**NOTICE OF DECISION TO CONSENT TO AMEND A REFERRED PROPOSAL  
DURING ASSESSMENT**

McPhee Creek Iron Ore Project  
Assessment No. 2285

**Summary of reasons for decision – request to amend a referred proposal during assessment under s. 43A of the *Environmental Protection Act 1986***

Figure 1: Location of McPhee Creek Iron Ore project, the proposals indicative footprint and amended wetting fronts associated with the amended proposal

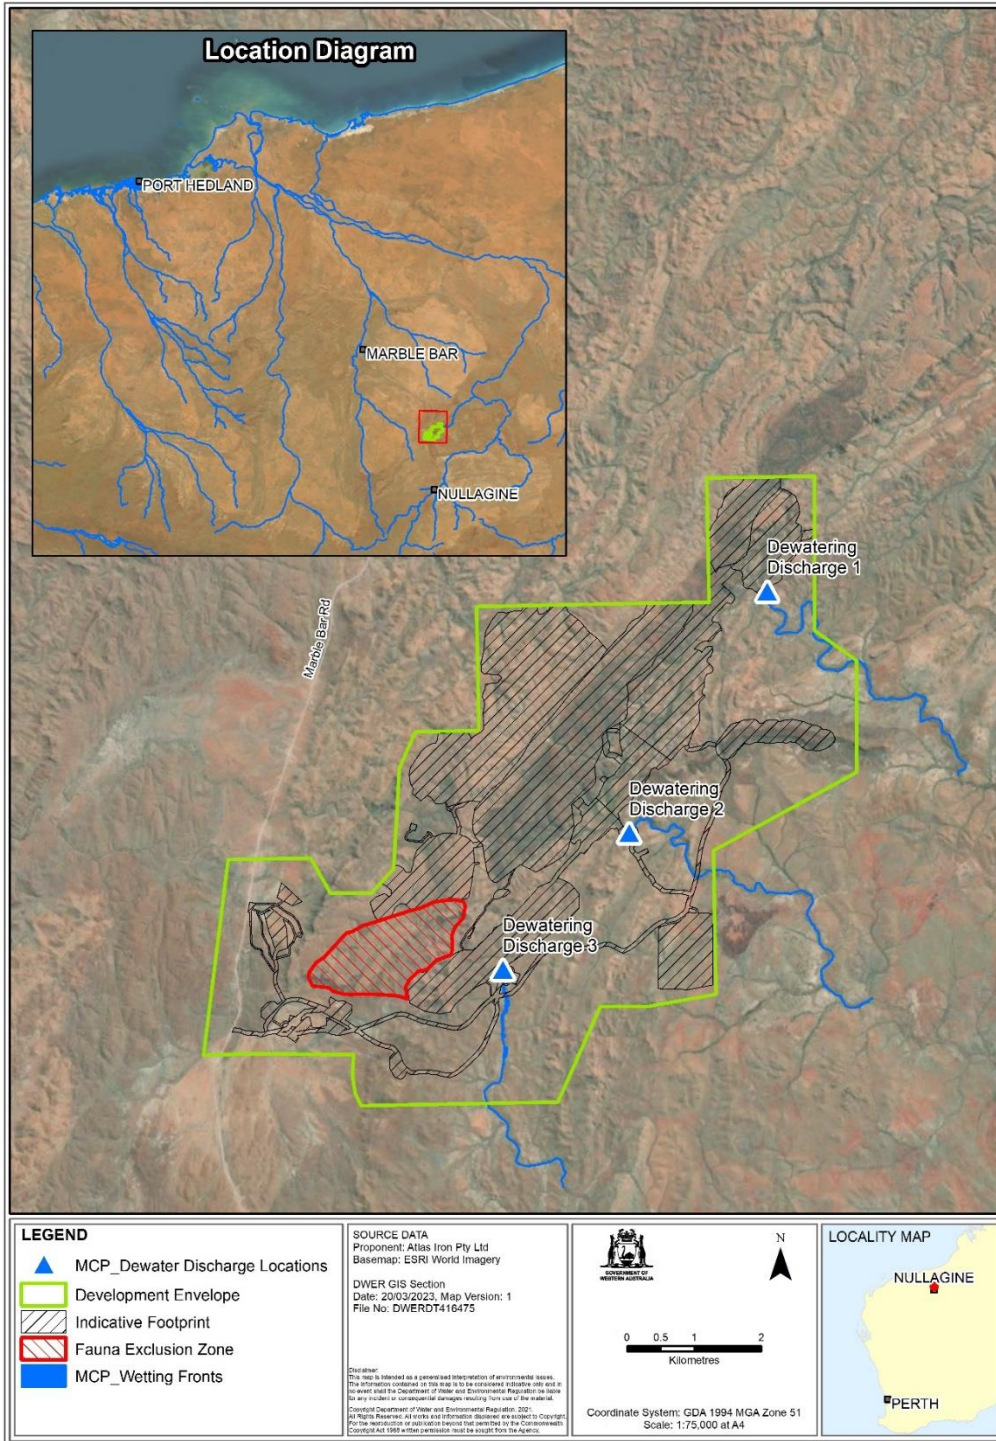
- A reduction in the maximum groundwater abstraction rate for mine dewatering (from 16 GL/a down to 7.5 GL/a);
- An associated reduction in dewater discharge volumes (from ~ 13 GL/a down to 6.0 GL/a). Approval is being sought for the amended 'Worst Case' scenario.
- An increase of 24.5 ha to the extent of clearing of 'high value' fauna habitat resulting from the inclusion of Spinifex Sandplain habitat as 'high value' habitat (with no change the overall amount of land to be cleared).

<b>Operational elements</b>		
Groundwater abstraction	Within Development Envelope (Figure 1)	Abstraction of up to 7.5 GL/a groundwater for mine dewatering
Surplus water management	McPhee Creek, branch of MCPhee Creek and Lionel Creek (Figure 1)	Controlled surface discharge of surplus water to three creek lines within the wetting fronts as shown in Figure 1

Figure 1: Location of McPhee Creek Iron Ore project, the proposals indicative footprint and amended wetting fronts associated with the amended proposal.

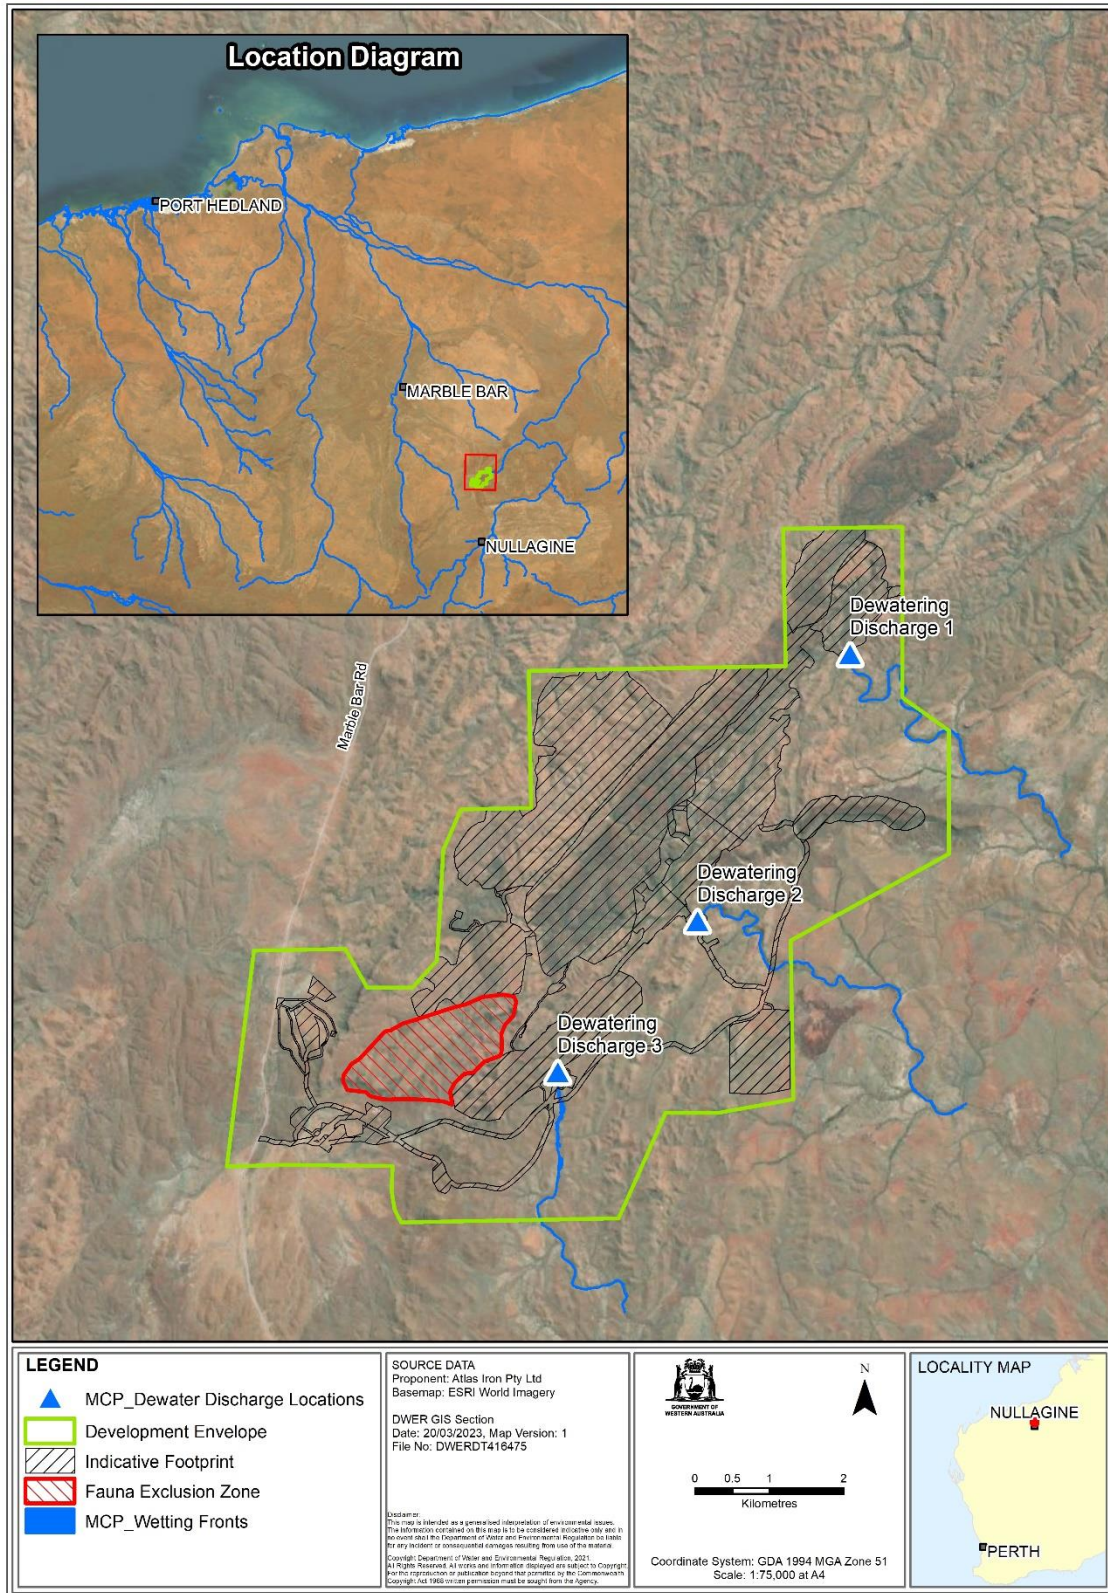
- A reduction in the maximum groundwater abstraction rate for mine dewatering (from 16 GL/a down to 7.5 GL/a) and an associated reduction in dewater discharge volumes (from ~ 13 GL/a down to 6.0 GL/a) (Table 1, Figure 2). Approval is being sought for the amended 'Worst Case' scenario.
- An increase of 24.5 ha to the extent of clearing of 'high value' fauna habitat resulting from the inclusion of Spinifex Sandplain habitat as 'high value' habitat.

Amendment sought	Changes to environmental impacts
<p>GL/a to up to 7.5 GL/a for mine dewatering (see Figure 3).</p>	<p>The amendment is likely to result in a reduction in the distance of the wetting fronts downstream, in particular for McPhee Creek and Lionel Creek. The maximum 'worst case' wetting fronts for each of the creeks (Figure 1) are:</p> <ul style="list-style-type: none"> <li>• 6.9 km (54% reduction from the original 15 km) in McPhee Creek</li> <li>• 6.8 km (~3% reduction from the original 7 km) in Branch of McPhee Creek</li> <li>• 4.4 km (63% reduction from the original 12 km) in Lionel Creek</li> </ul> <p>Long-term discharge has the potential to create mounding in the alluvial aquifer but is not expected to have a significant impact on the broader alluvial aquifer. The modelled wetting fronts are likely to be less than that proposed in this amendment and are predicted to remain within the Development Envelope (Figure 1) and dewater discharge water quality is expected to remain high. The groundwater flow and surface water modelling is considered to be in accordance with industry standards.</p> <p>A reduction in the distance downstream of the wetting fronts is likely to decrease the risk of impact on aquatic fauna within the downstream pools. Noting dewater discharge during natural dry season no-flow conditions has predicted discharge water to be received by the temporary/seasonal pool VMPC-77 on Branch of McPhee Creek.</p> <p>- <b>Subterranean Fauna</b> Proposed shallower mining pits, and a proposed reduction in the extent of mining (e.g. Murray Pit as detailed in the amended mine plan), is predicted to lower (~26% reduction) the total volume of dewatering required (63 GL worst case compared to the original 85 GL). A slightly reduced impact on stygofauna habitat is likely as the vertical and in some areas horizontal extent of dewatering, and therefore habitat loss is predicted to be reduced.</p> <p>Likely increased impacts to:</p> <p>- <b>Flora and Vegetation</b> Under the proposed amendment ( i.e., a lower amount, longer-term abstraction regime (Figure 2)); a total of 58.7 ha (50.0 ha within the Development Envelope) of groundwater-dependant vegetation (GDV) could experience a drawdown of</p>

The EPA considers the amended proposal to be substantially the same character as the existing referred proposal and does not consider that the amendment would be significant amendment if the proposal were already approved. The EPA considers it has enough information to reasonably proceed with the assessment of the amended proposal without performing any additional functions at this stage.

Figure 2: Comparison of proposed amended water discharge volumes ('Worse Case') to the original proposal submission (figure extracted from S43A supporting information)

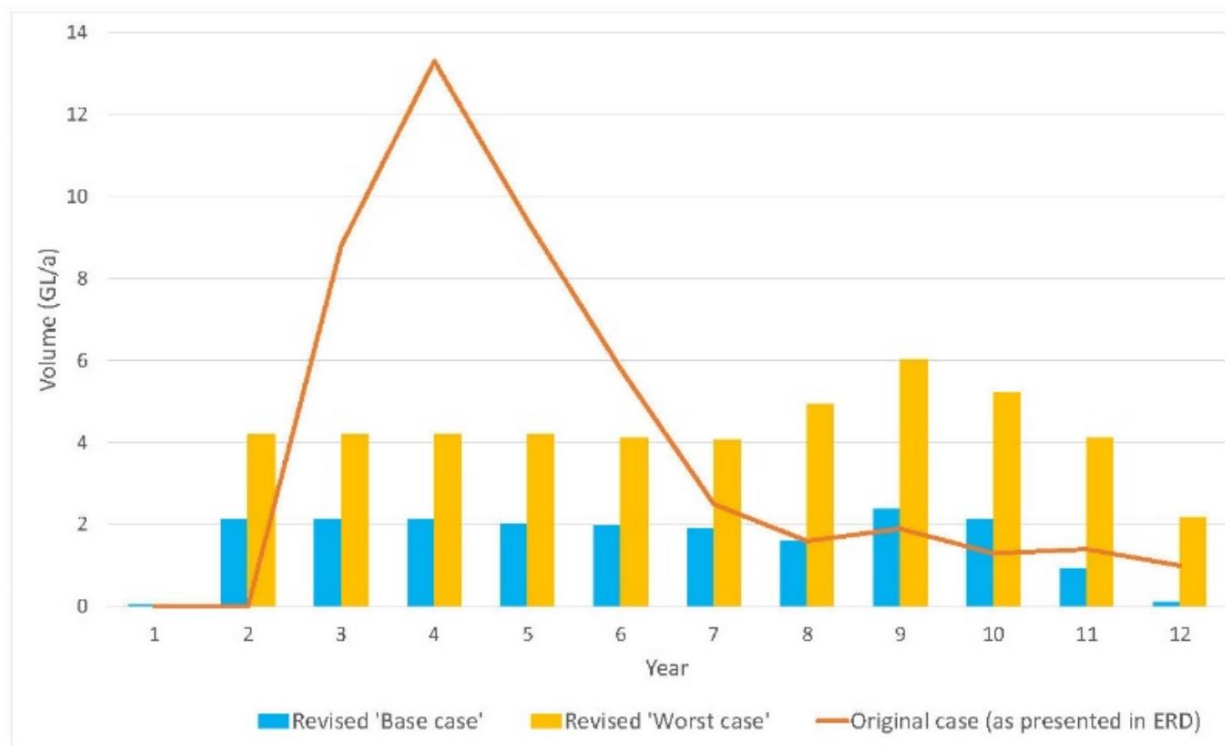
Surplus water management	Controlled surface discharge of surplus water to three creek lines (to a peak of ~ 13 GL) within the wetting fronts (as shown as 'original case' in Figure 4)	Reduction in the controlled surface discharge of surplus water to three creeklines by 7 GL/a.	<b>Controlled surface discharge of surplus water to three creek lines (up to 6.0 GL/a) within the wetting fronts (see Error! Reference source not found.)</b>
<b>Proposal elements with greenhouse gas emissions</b>			
<b>Construction elements: Annual average</b>			
Construction Vegetation clearing	Scope 1 - 98,688 tonnes of CO2-equivalence (t CO2-e)	No change	No change
<b>Operational elements: Annual Average Life of Mine</b>			
Operations - Production - Energy production - Wastewater emissions	Scope 1 – 57,095 t CO2-e	No change	No change
<b>Rehabilitation</b>			
Where practicable, progressive rehabilitation will be undertaken over the life of the mine.	Areas disturbed through the implementation of the Proposal will be designed to be safe and non-polluting and will be constructed so the final shape, size, stability, are comparable with the natural landforms in the area.	No change	No change
